ADDENDUM NO. CC-1

to the  
Bidding Documents

BLOOMER ELEMENTARY SCHOOL  
REMODEL  
210 S. 7<sup>th</sup> Street  
Council Bluffs, Iowa 51503  
BCDM Project No. 3103-01

## addendum

sketch M1-4b

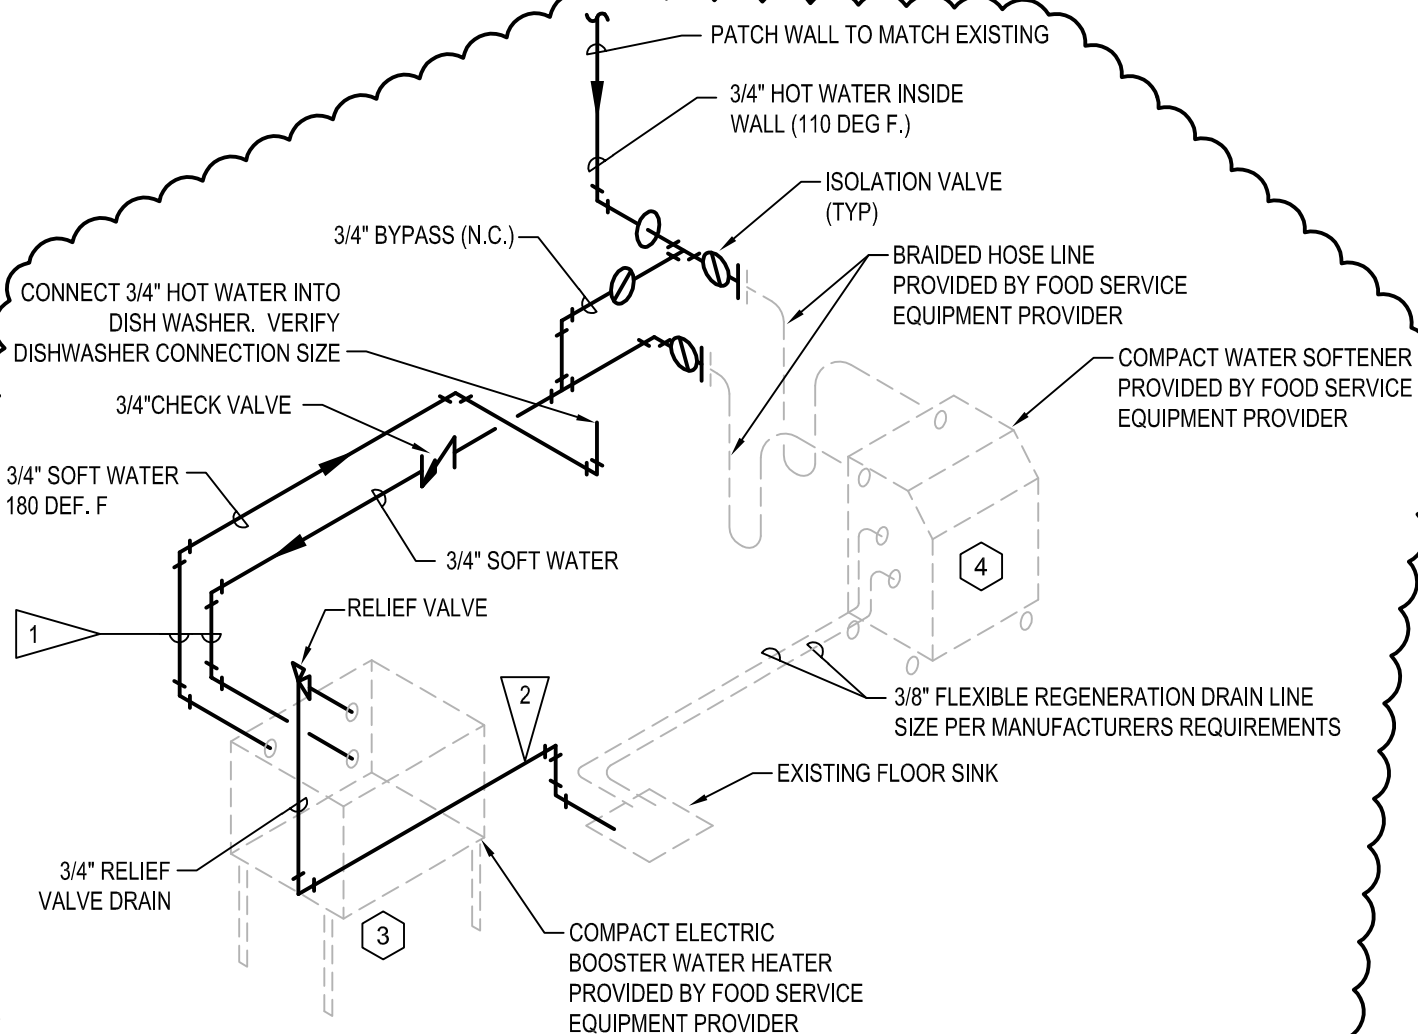
- a. Alternate Bid No 1: Provide new piping, ductwork and exhaust fan as indicated on this sheet.
  - b. See sketches M1-4a and M1-4b

- 1 INSULATE EXPOSED HOT WATER PIPING BELOW DISHWASHER WITH INSULATION AND COVER WITH WHITE PVC COVER. REFERENCE SPECIFICATIONS FOR INSULATION REQUIREMENTS. ATTACH PIPING TO WALL WITH STAINLESS STEEL "AVERY" DOUBLE SPLIT RING SUPPORTS. PIPING SHALL HAVE A 1" GAP BETWEEN WALL AND PVC INSULATION COVER.
- 2 SUPPORT PIPING MINIMUM 4" ABOVE A.F.F. UTILIZE STAINLESS STEEL "AVERY" DOUBLE SPLIT RING SUPPORT BRACKETS FOR ATTACHMENT TO WALL. (UNISTRUT NOT ALLOWED) PIPING SHALL HAVE A 1" GAP BETWEEN WALL PIPING

sketch **ED1-0a**

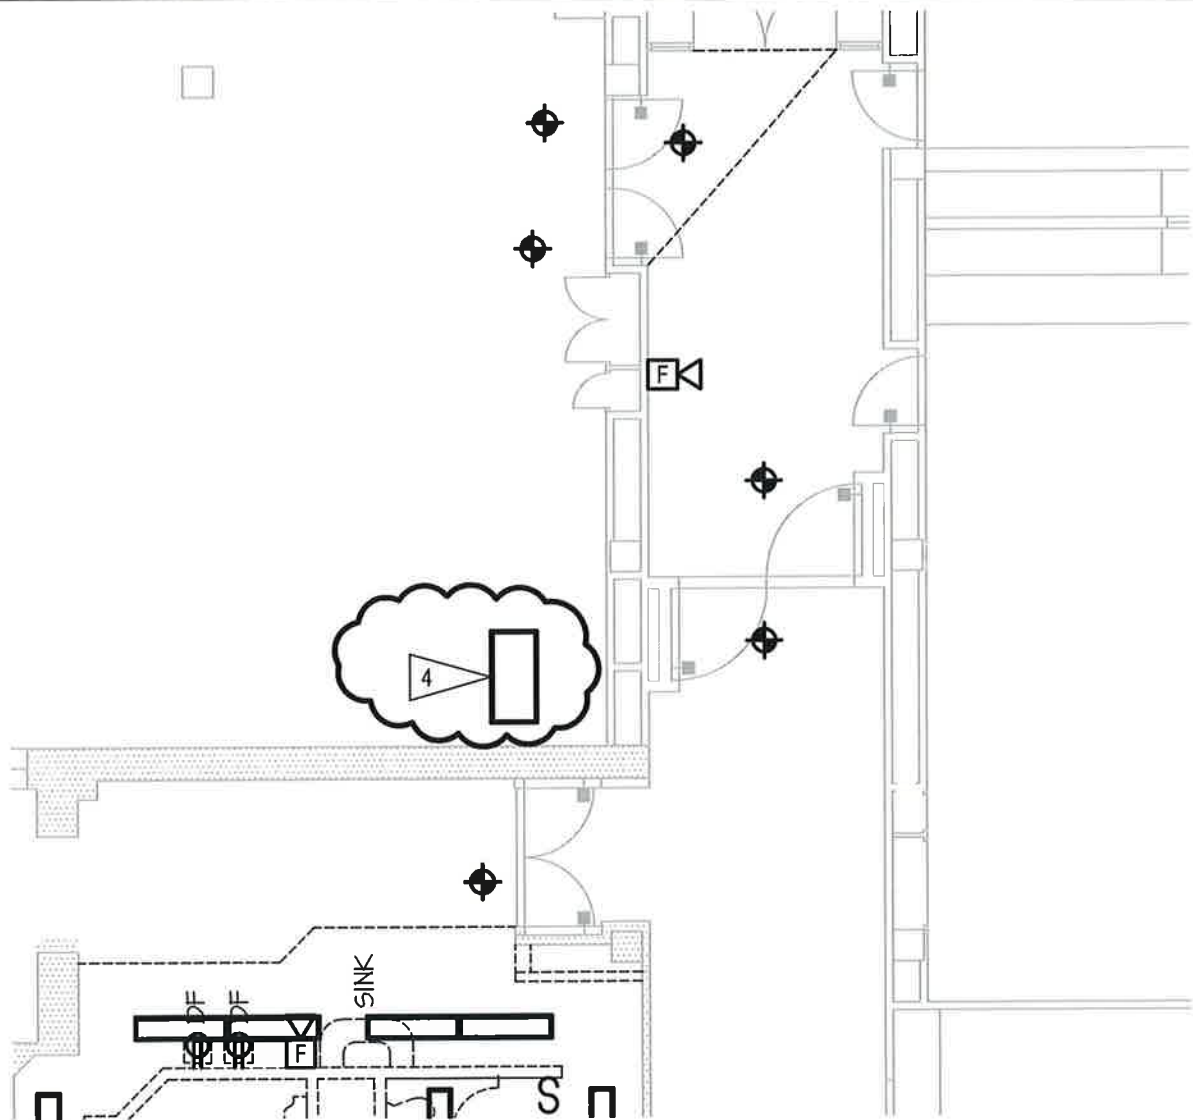
1. Sheet ED1-0 Basement Floor Plan - Electrical Demolition
  - a. See Sketch ED1-0a
2. Sheet ED1-1 First Floor Plan - Electrical Demolition
  - a. See Sketch ED1-1a
3. Sheet E1-1 First Floor Plan - Lighting
  - a. See Sketch E1-1a, E1-1b, and E1-1c
4. Sheet E1-2 Second Floor Plan - Lighting
  - a. See Sketch E1-2a
5. Sheet E1-3 Third Floor Plan - Lighting
  - a. See Sketch E1-3a
6. Sheet E2-1 First Floor Plan - Power
  - a. See Sketch E2-1a
7. Sheet E2-2 Second Floor Plan - Power
  - a. See Sketch E2-2a
8. Sheet E2-3 Third Floor Plan - Power
  - a. See Sketch E2-3a

-  EXISTING EQUIPMENT TO REMAIN.
-  REMOVE EXISTING BOOSTER HEATER CIRCUIT BREAKER IN EXISTING MAIN SWITCHBOARD. SEE E2.1 FOR NEW CIRCUIT BREAKER INFORMATION.

| project no.: 12340 | drawing referenced: ED1-1 | <b>ED1-1a</b> |

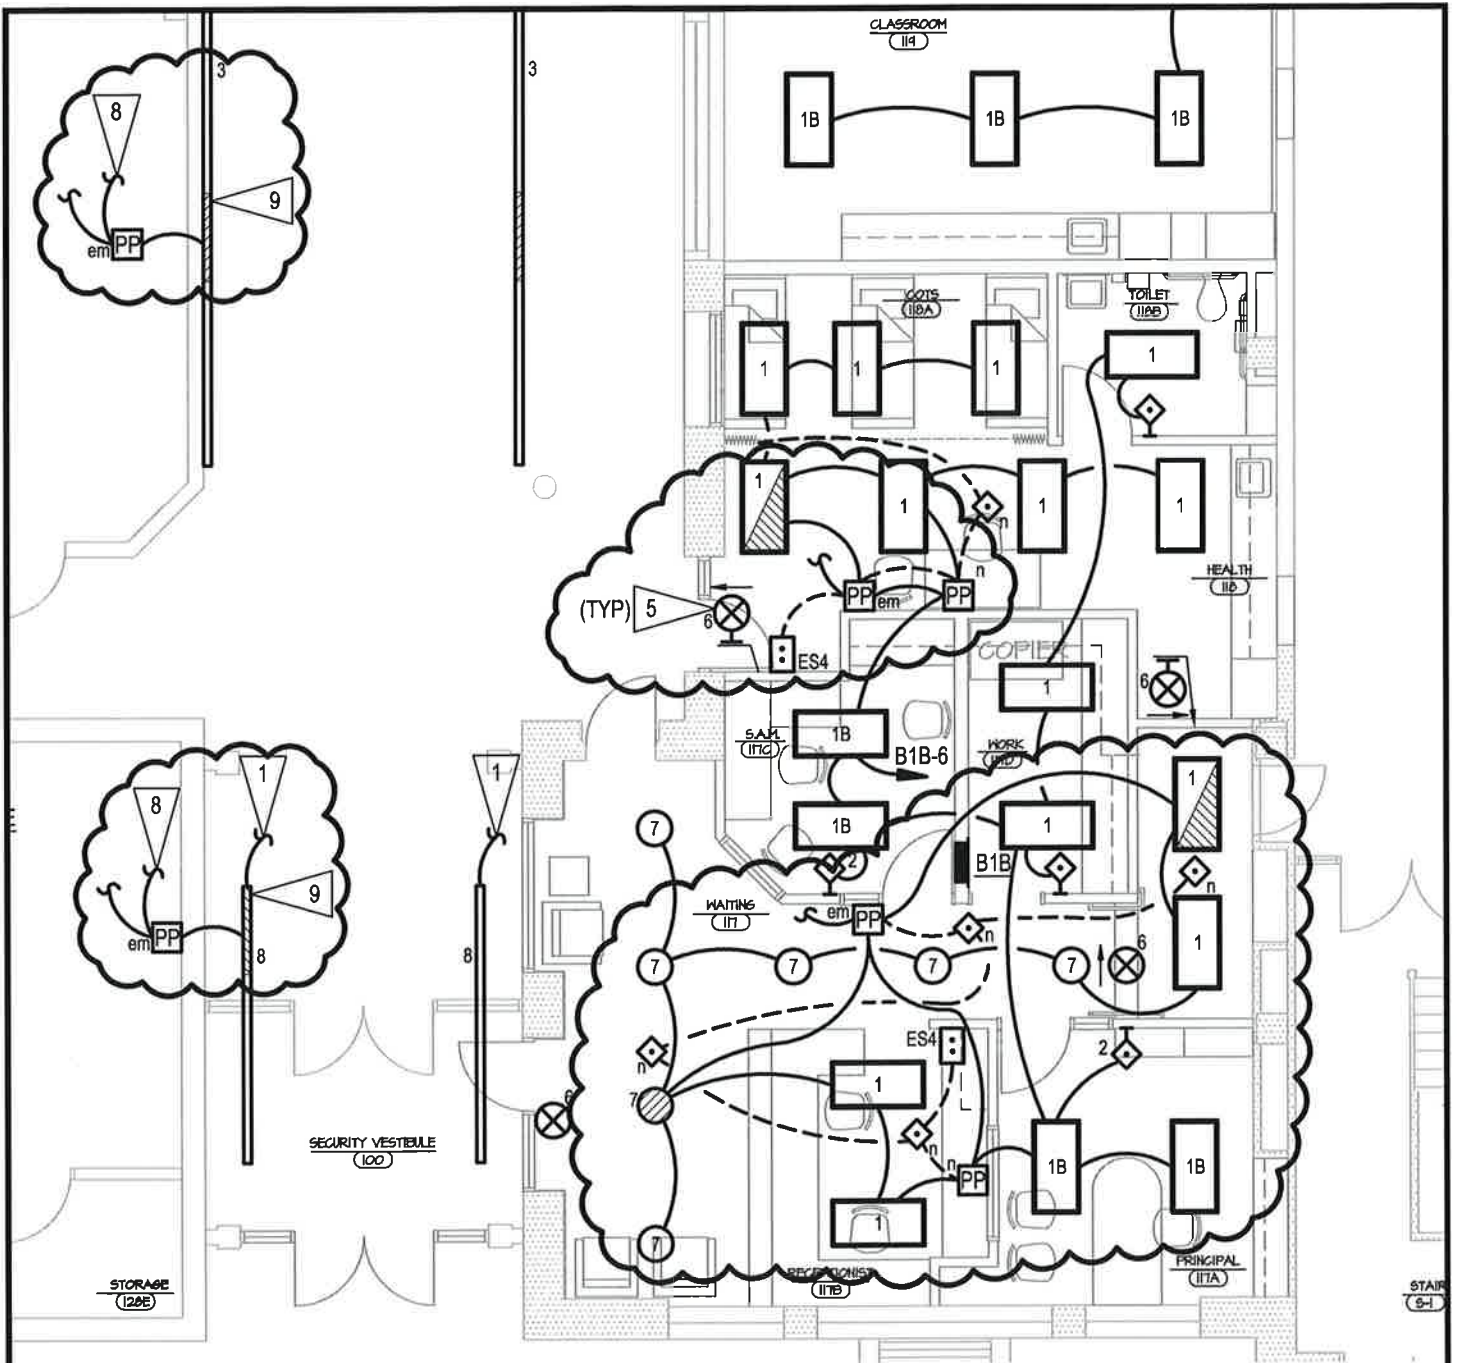
2 REMOVE EXISTING FEEDERS AND ASSOCIATED CONDUIT TO MAIN SWITCHBOARD.

3 THIS SPACE, REMOVE DEVICES WHERE WALLS ARE REMOVED. ALL OTHER DEVICES AND FIXTURES NOT AFFECTED BY NEW WORK ARE TO REMAIN. SEE E1.1, E2.1, AND E3.1 FOR NEW WORK.

4 EXISTING LIGHT FIXTURE AND ASSOCIATED CIRCUIT TO BE RELOCATED TO ACCOMMODATE NEW WORK. SEE E1.1 FOR MORE INFORMATION.

| project no.: 12340 | drawing referenced: E1-1 | <b>E1-1c</b> |

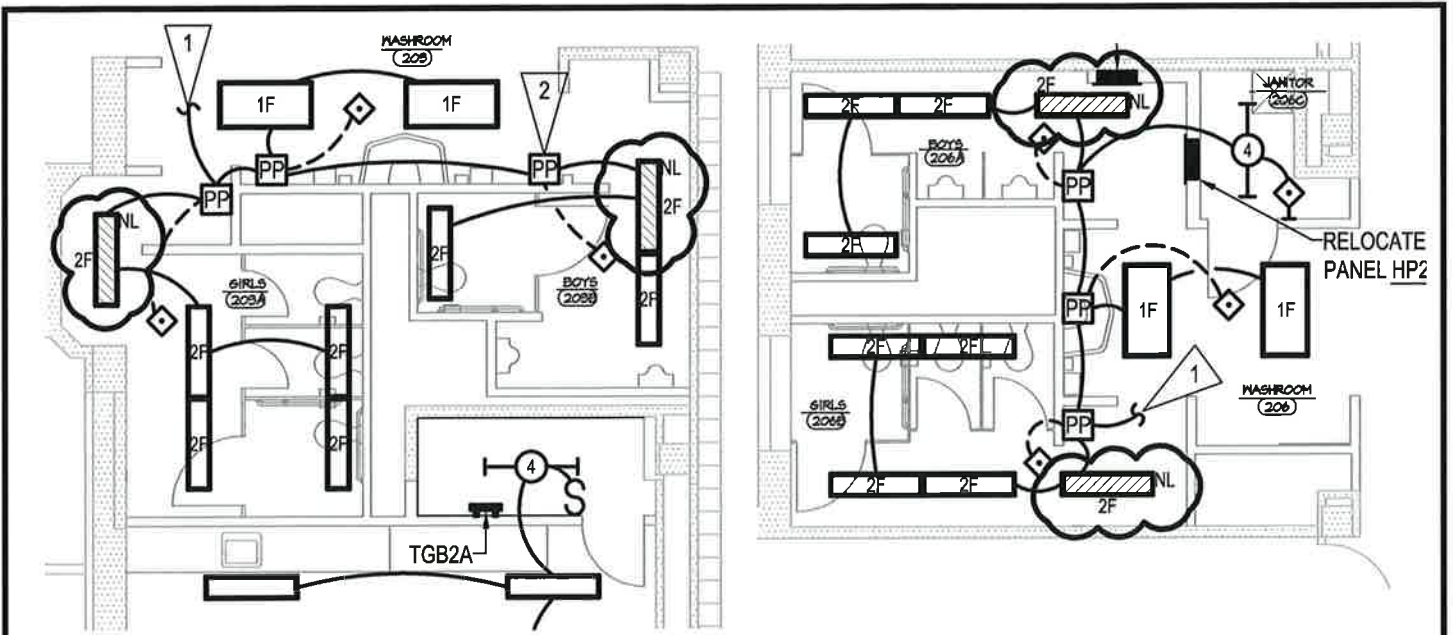
1. CONNECT LIGHT FIXTURES TO SWITCH MADE SPARE BY DEMOLITION.
2. CUT AND PATCH WALL TO EXTEND EXISTING POWER FEED UP NEAR HORIZONTAL BULKHEAD. MOUNT FIXTURE TO BOTTOM OF HORIZONTAL BULKHEAD. VERIFY FIXTURE MOUNTING LOCATION WITH ENGINEER.
3. SEE DETAIL 5/E5-1 FOR TYPICAL LIGHTING CONTROLS COMMUNICATION CONNECTIVITY DIAGRAM.
4. SEE DETAIL 5/E5-1 FOR TYPICAL STAND ALONE OCCUPANCY SENSOR.
5. CONNECT EXIT SIGNS TO NEAREST GENERATOR CIRCUIT SERVING AREA.
6. CONNECT EMERGENCY RELAY POWER PACK TO NEAREST GENERATOR CIRCUIT SERVING AREA.
7. PROVIDE UNSWITCHED NORMAL POWER TO EMERGENCY RELAY POWER PACK.
8. RECONNECT FIXTURE TO EXISTING CIRCUIT SERVING AREA.
9. CONNECT 4'-0" SECTION OF FIXTURE TO EMERGENCY GENERATOR CIRCUIT SERVING AREA.

E2-1a

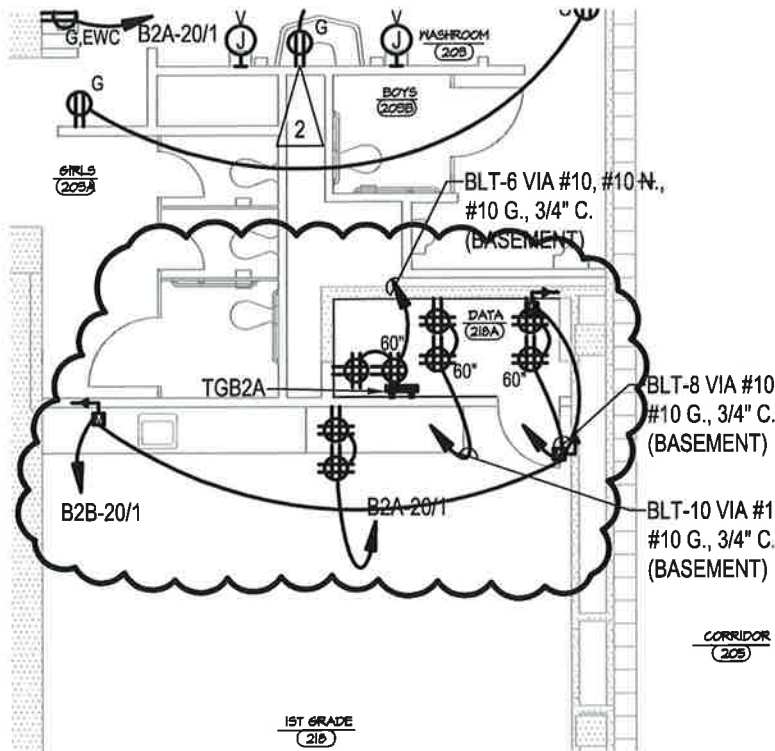
- 9 > PROVIDE A 90/3 CIRCUIT BREAKER IN EXISTING SPACE MADE AVAILABLE BY DEMO LABELED "BOOSTER HEATER" IN MAIN SWITCHBOARD.
- 10 > VERIFY REFRIGERATOR LOCATION WITH ARCHITECT PRIOR TO ROUGH-IN.
- 11 > PROVIDE CONTROL WIRING IN 1/2" C. TO ASSOCIATED INDOOR UNIT. RACK CONDUIT WITH CONDENSATE PIPING.
- 12 > UNDER ALTERNATE #1 PROVIDE CONNECTION TO NEW DISHWASHER AND BOOSTER HEATER.
- 13 > ROUTE CONDUIT DOWN INSIDE WALL TO DISCONNECT AT 18" A.F.F. EXTEND LFMC FROM DISCONNECT TO BOOSTER HEATER BELOW CLEAN DISHTABLE.
- 14 > ROUTE CONDUIT FROM EXISTING JUNCTION BOX IN WALL TO DISCONNECT AT 74" A.F.F. EXTEND LFMC FROM DISCONNECT TO DISHWASHER.
- 15 > ROUTE CONDUIT DOWN INSIDE WALL TO JUNCTION BOX AT 70" A.F.F. EXTEND LFMC FROM JUNCTION BOX TO DISHWASHER, AND INTERLOCK DISHWASHER EXHAUST FAN ON ROOF WITH VENT FAN CONTROL ON DISHWASHER.

sketch **E3-0a**

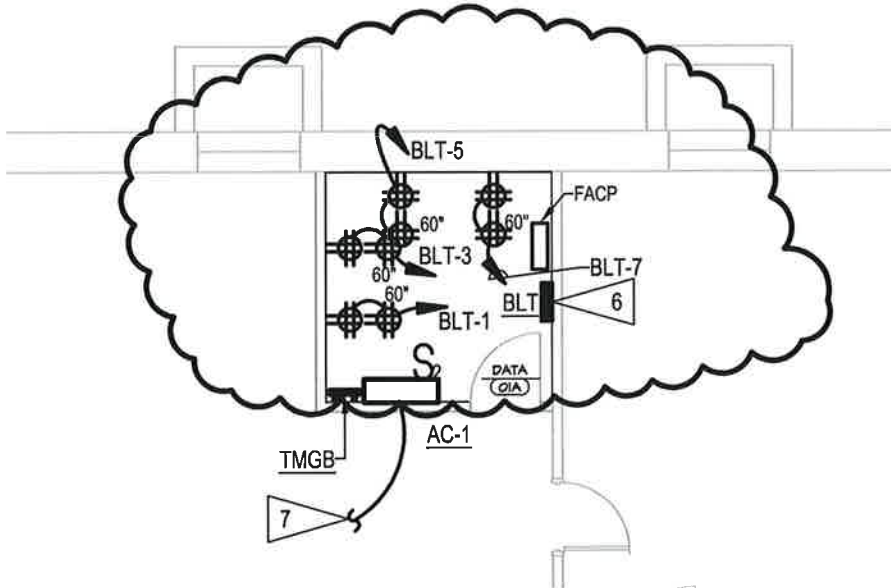
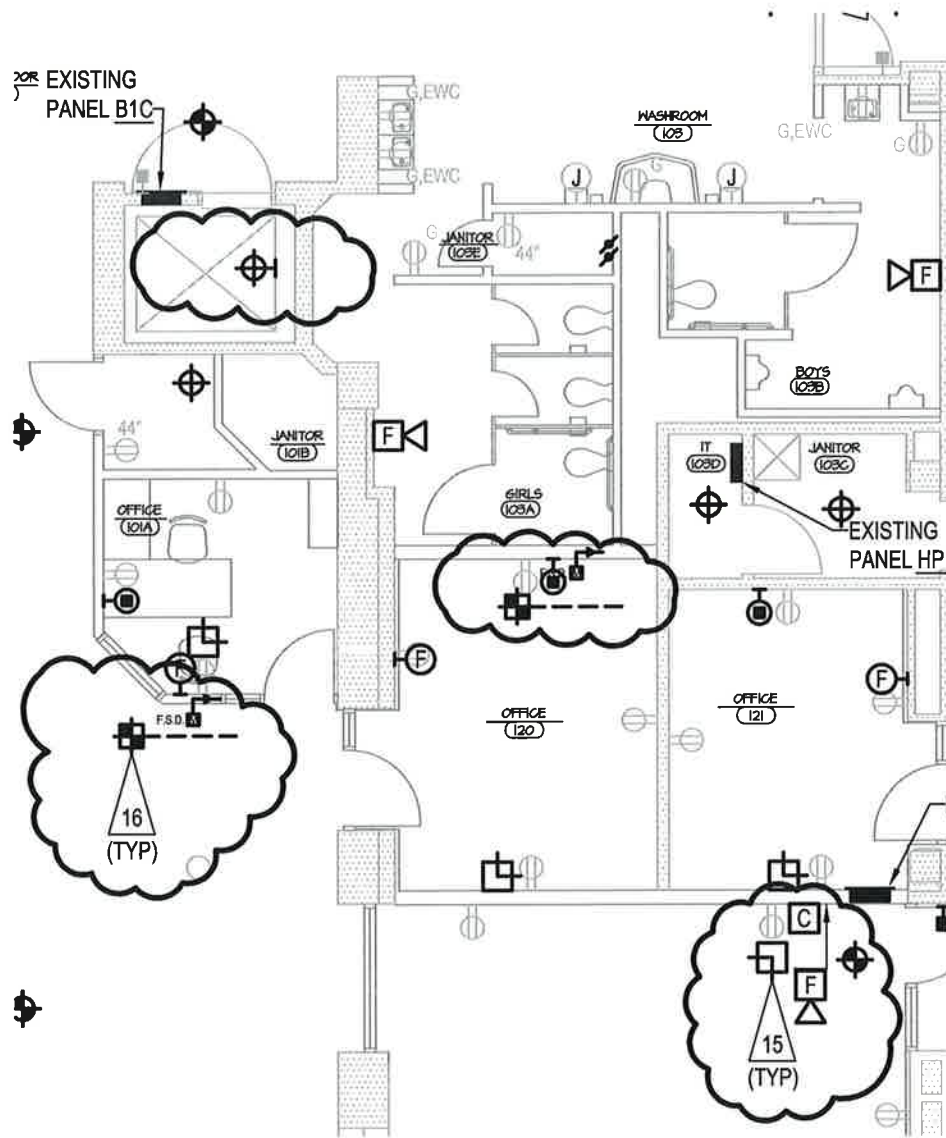
9. Sheet E3-0 Basement Floor Plan - Lighting, Basement Floor Plan - Power
  - a. See Sketch E3-0a

sketch **E3-1a**

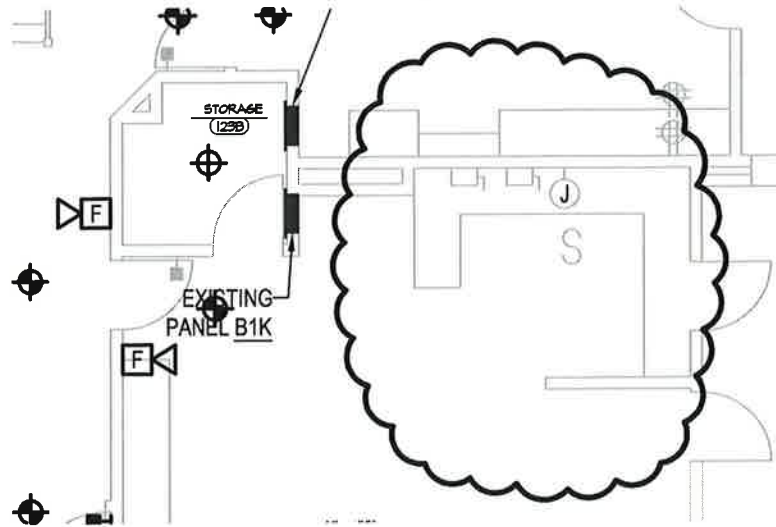
10. Sheet E3-1 First Floor Plan - Special Systems
  - a. See Sketch E3-1a and E3-1b

1 RECONNECT EXISTING MAGNETIC DOOR HOLDERS TO FIRE ALARM SYSTEM.

2 REPLACE EXISTING CUSTOM FLUSH TRIM PLATE WITH NEW CUSTOM IVORY TRIM PLATE FOR NEW FLUSH MOUNT FIRE ALARM ANNUNCIATOR.

14 PROVIDE PROJECTOR MOUNT, CHIEF #KITP S006W. COORDINATE PROJECTOR MOUNT LOCATION WITH OWNER PRIOR TO INSTALLATION. RELOCATE CEILING MOUNT RECEPTACLES NEXT TO NEW PROJECTOR MOUNT LOCATION. EXTEND RECEPTACLE CIRCUITS TO ACCOMMODATE NEW LOCATION. FINAL PROJECTOR INSTALLATION BY OWNER.

**E3-1b**

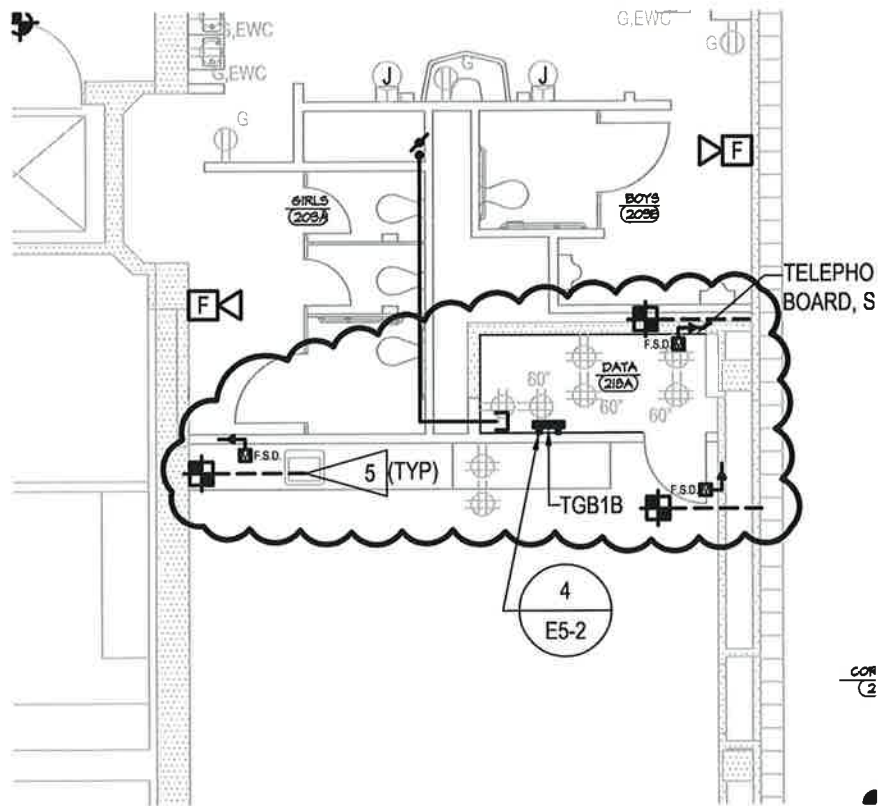
2 COORDINATE DEVICE LOCATIONS WITH NEW CASEWORK.

3 THIS ROOM, PROVIDE ONE (1) DATA/COMMUNICATION ROUGH-IN, SEE 1/E5-1, PROVIDE ONE (1) AV ROUGH-IN SIMILAR TO 1/E5-1, AND ONE TELEPHONE OUTLET ROUGH-IN. ALL NEW ROUGH-INS IN THIS ROOM SHALL BE METAL WIREMOLD STYLE SURFACE RACWAY COORDINATE ROUGH-IN LOCATIONS WITH OWNER.

4 PROVIDE PROJECTOR MOUNT, CHIEF #K11P S006W. COORDINATE PROJECTOR MOUNT LOCATION WITH OWNER PRIOR TO INSTALLATION. RELOCATE CEILING MOUNT RECEPTACLES NEXT TO NEW PROJECTOR MOUNT LOCATION. EXTEND RECEPTACLE CIRCUITS TO ACCOMMODATE NEW LOCATION. FINAL PROJECTOR INSTALLATION BY OWNER.

5 DUCT SMOKE DETECTOR SHALL CLOSE ASSOCIATED DAMPER UPON DETECTION OF SMOKE.
